ATTACHMENT 1

PROPOSED TECHNICAL SPECIFICATION CHANGE NO. 84

## 6.0 ADMINISTRATIVE CONTROLS

TS FIG 6.1-2  
9-11-79

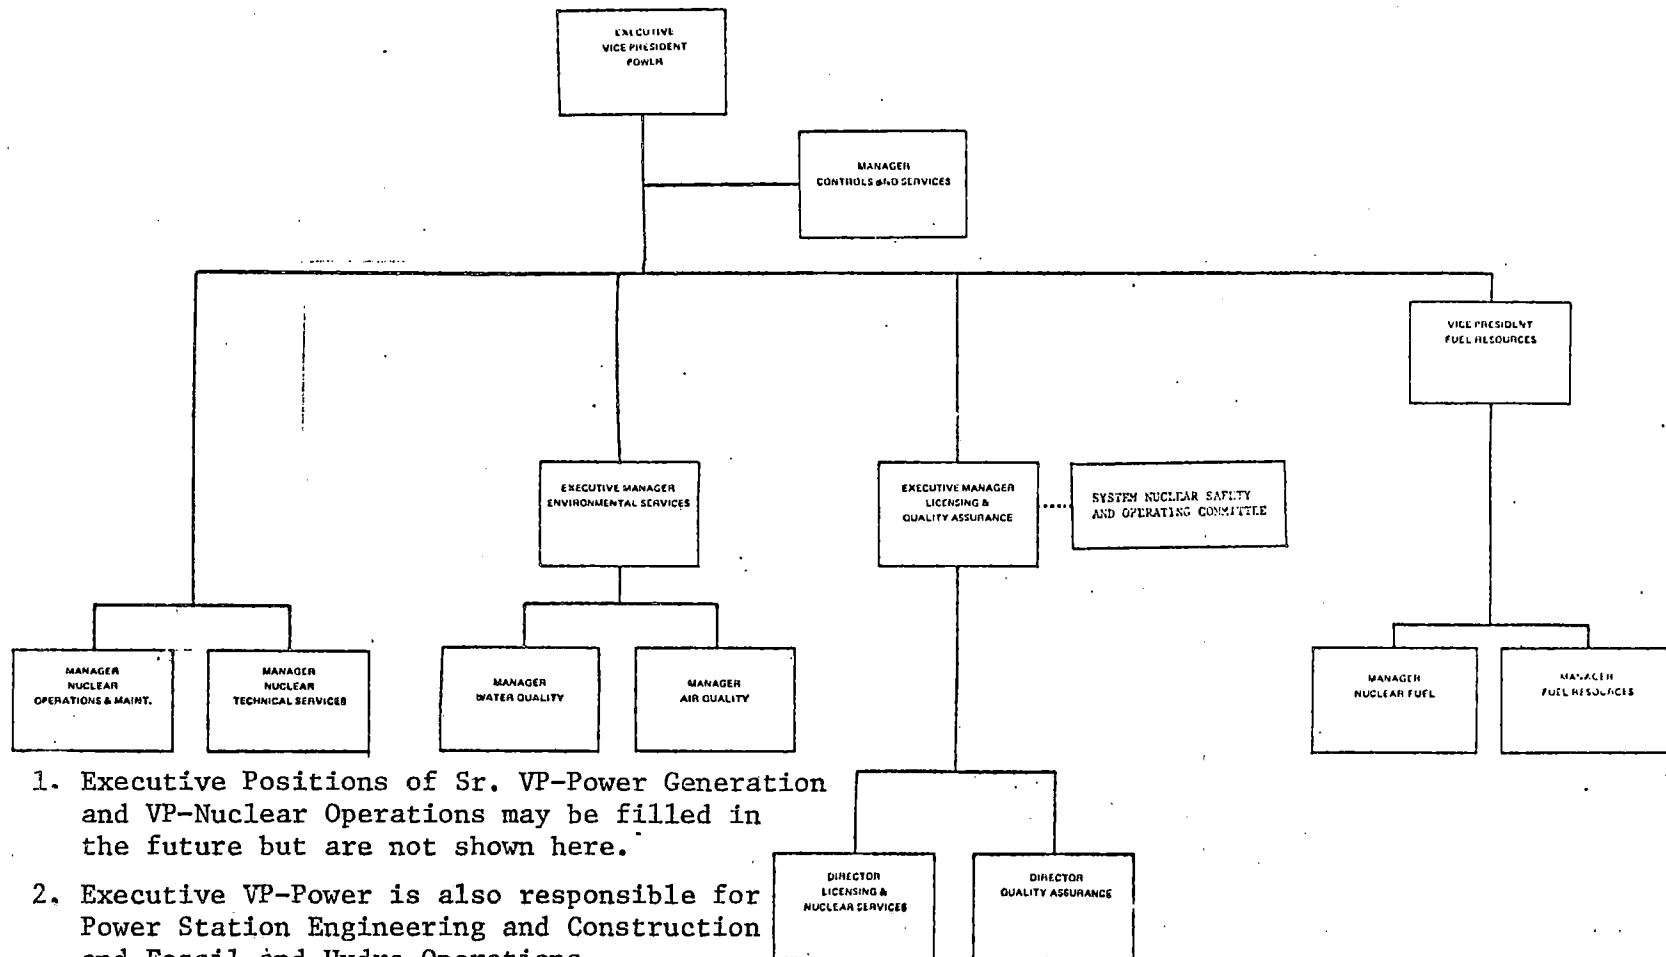
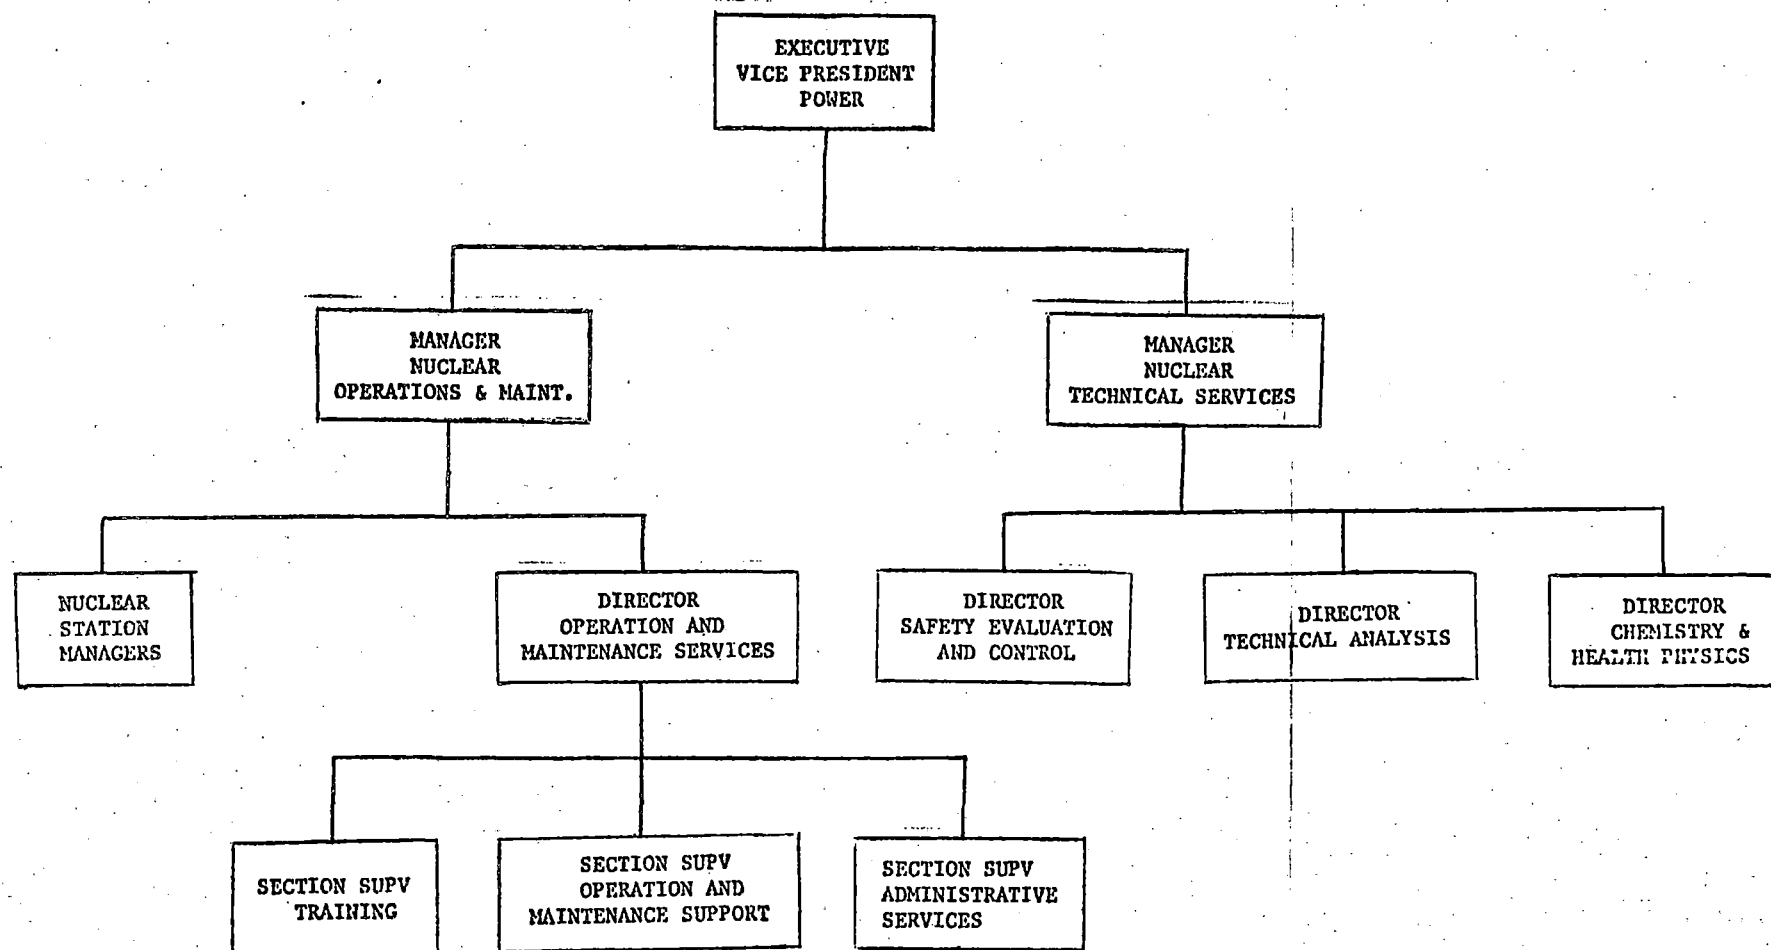
SEE ATTACHED SHEET

VIRGINIA ELECTRIC AND POWER COMPANY  
ORGANIZATION CHART  
POWER OPERATIONS  
(INTERIM)

- Notes:
1. Executive Positions of Sr. VP-Power Generation and VP-Nuclear Operations may be filled in the future but are not shown here.
  2. Executive VP-Power is also responsible for Power Station Engineering and Construction and Fossil and Hydro Operations.

TS FIG. 6.1-3  
9-11-79

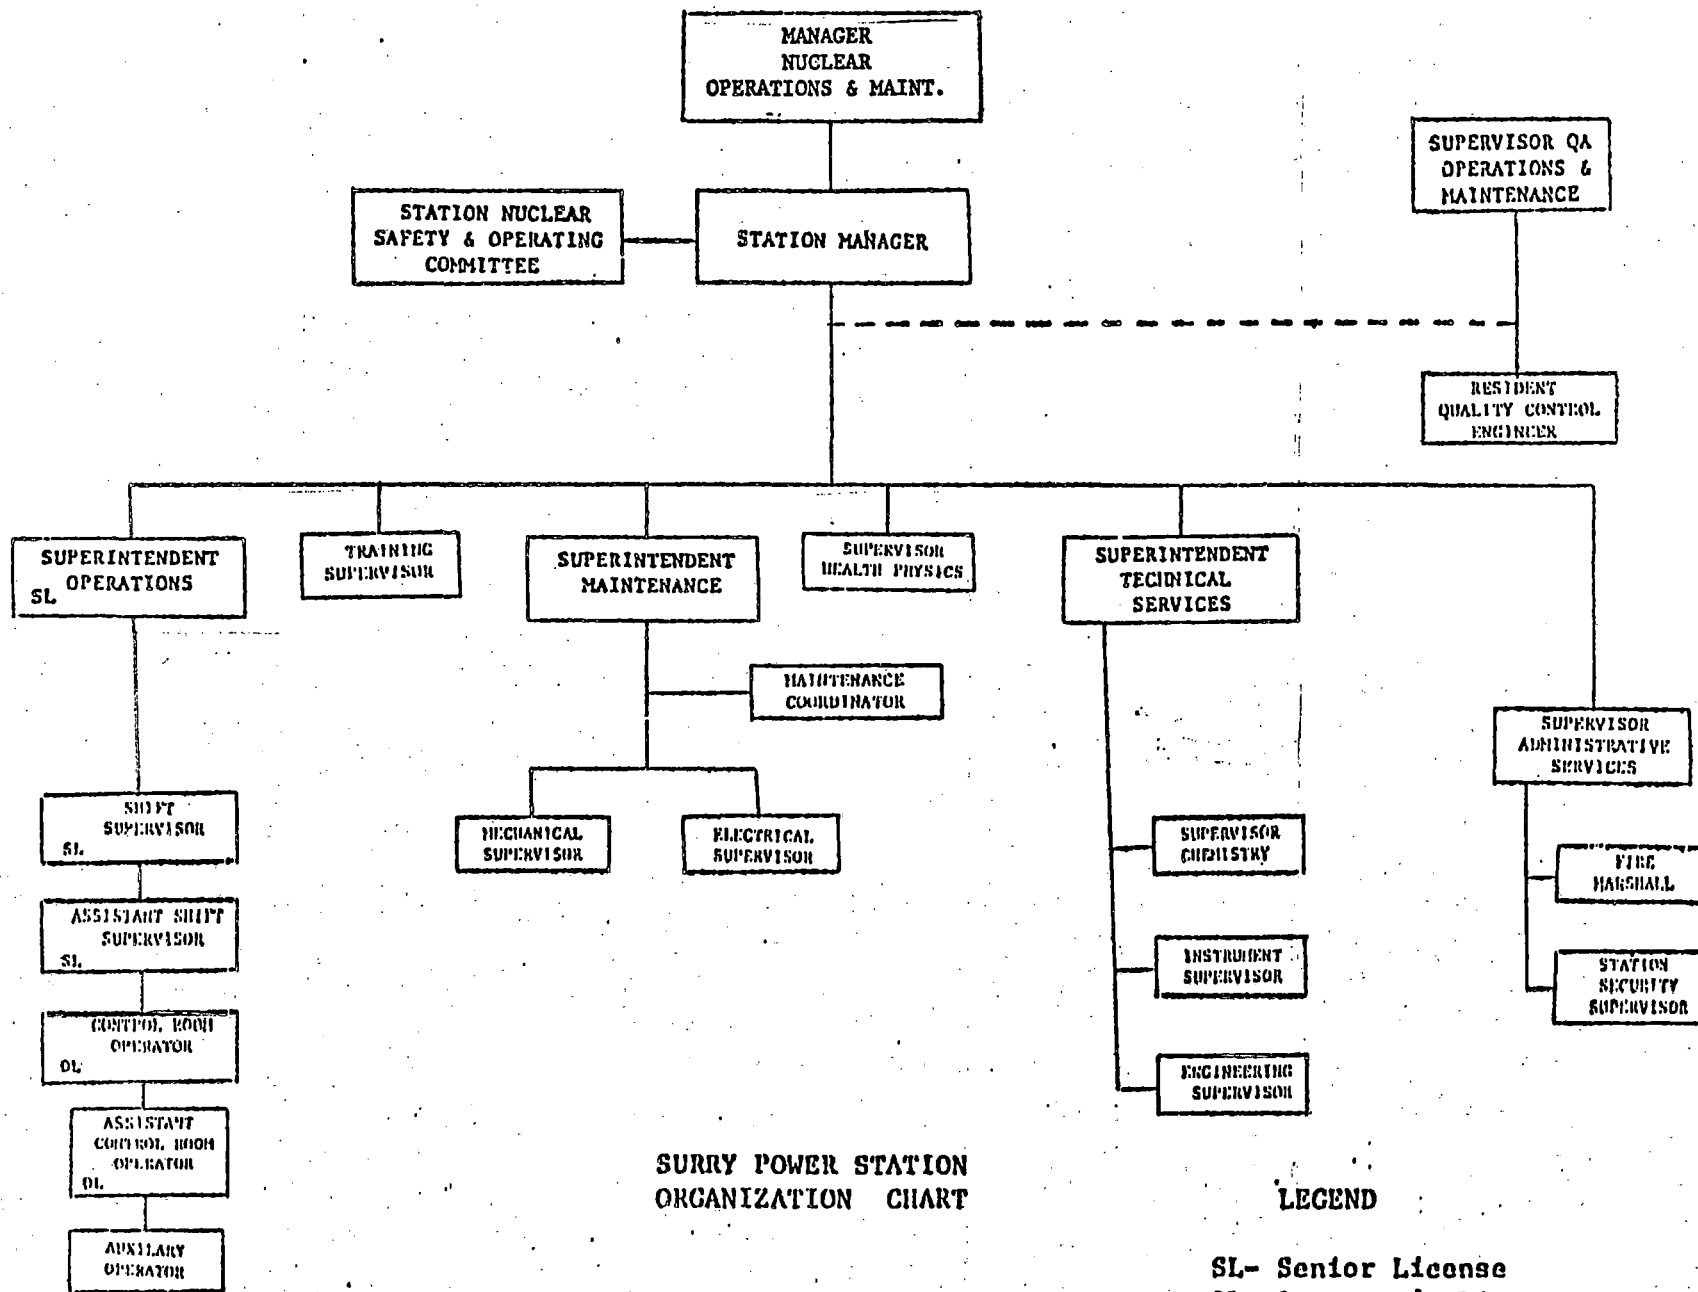
SEE ATTACHED SHEET
